UNITED STATES PATENT AND TRADEMARK OFFICE

| APPLICATION NO. | FILING DATE | FIRST NAMED INVENTOR | ATTORNEY DOCKET NO. | CONFIRMATION NO. |
|---------------------------------------------------------------------------------|-------------|----------------------|---------------------|------------------|
| 10/071,877 | 02/08/2002 | Robert C. Downs | 36-001810US | 9765 |

Office Action Summary

DETAILED ACTION

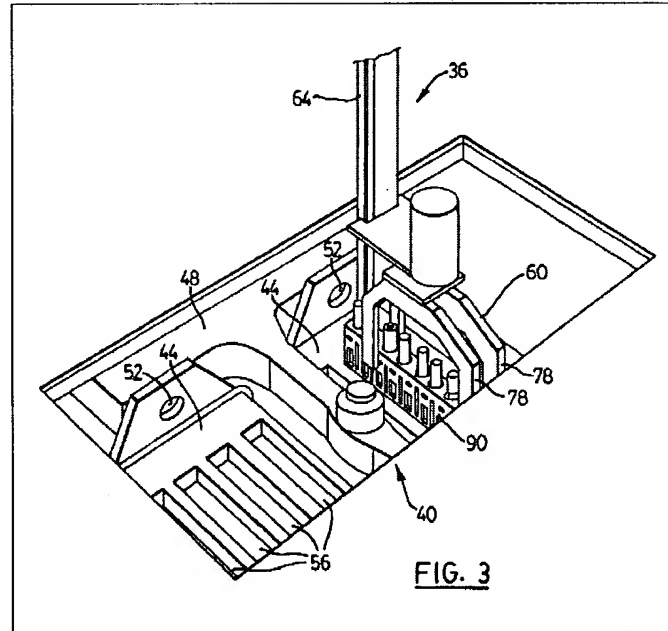
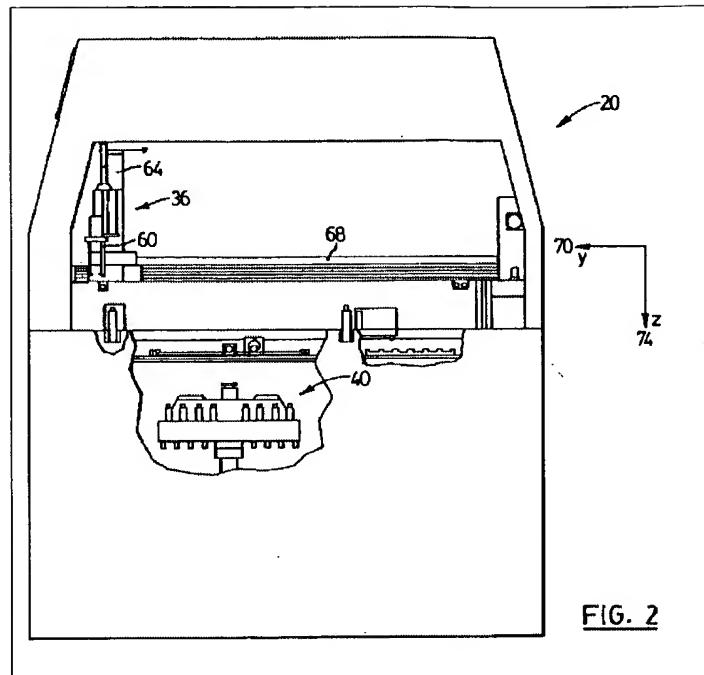
1. Claims 1, 4 – 20, 24 – 40, 48, 56, 58 and 85 – 113 are rejected under 35 U.S.C. 102(b) as being anticipated by Quinlan et al. (U.S. Pat. No. 5,769,775 A). Quinlan et al. teach an

automated centrifuge apparatus comprising: a rotor (40) comprising a plurality of sample receiving regions (56); and a transport mechanism (24, 94, 98) configured to move one or more sample processing components proximal to or within the plurality of sample receiving regions; and at least one robot (36) capable of inserting at least two sample vessels (44) into the sample receiving regions (56) (see col. 3, lines 15 – 67; col. 4, lines 1 – 65; figures 1 – 3).

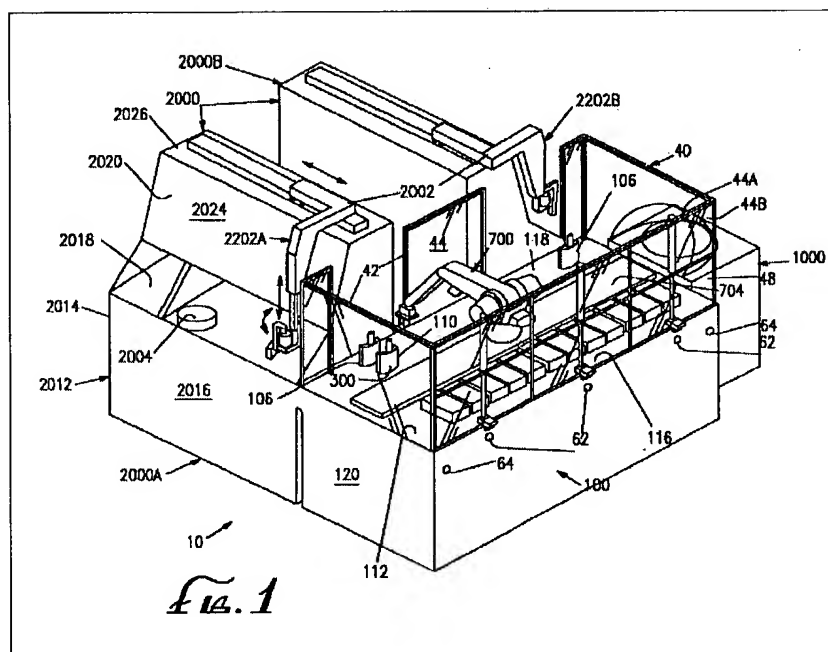
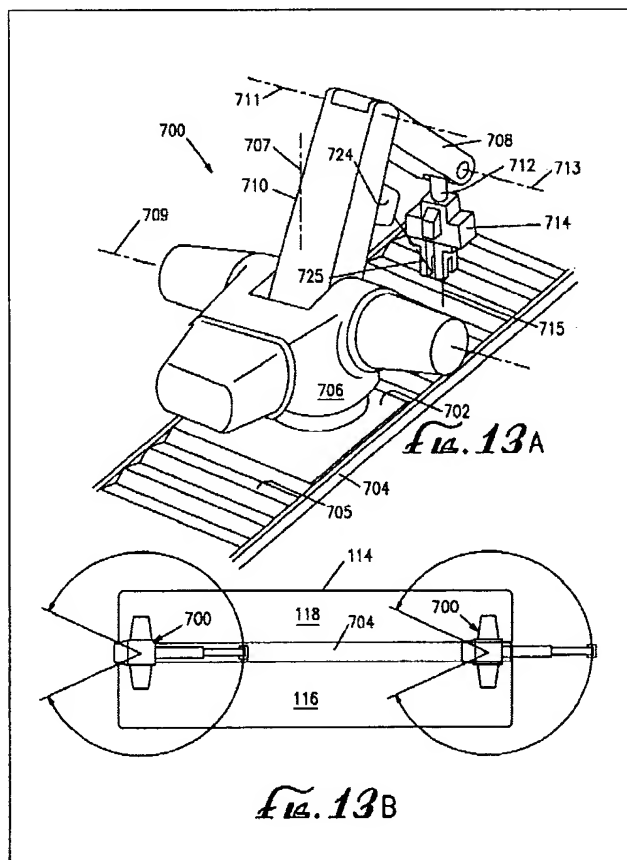
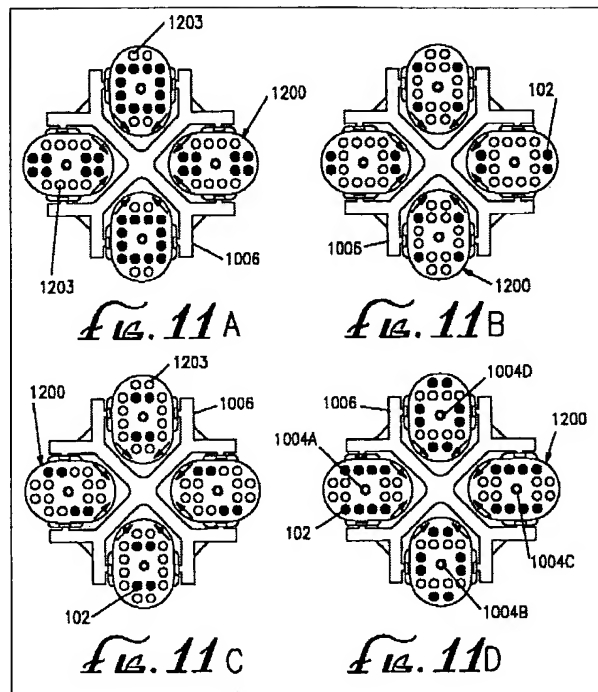
2. Claims 1 – 20, 24 – 44, 48 and 85 – 113 are rejected under 35 U.S.C. 102(e) as being anticipated by Pang et al. (U.S. Pat. No. 6,060,022 A). Pang et al. teach an automated centrifuge apparatus comprising: a centrifuge rotor (1000) comprising a plurality of sample receiving

regions (1200); and a transport mechanism (700) configured to move one or more sample processing components proximal to or within the plurality of sample receiving regions; and at least one robot (2002) capable of inserting at least two sample vessels, such as test tubes, into the sample receiving regions (1200) (see col. 1, line 1 – col. 14, line 64; figures 1 – 21). The apparatus includes an optical position sensor and an indicia scanner (see col. 8, lines 1 – 32). The apparatus comprises two analyzers for selectively performing at least two different analyses on a specimen (see col. 6, lines 51 – 67).
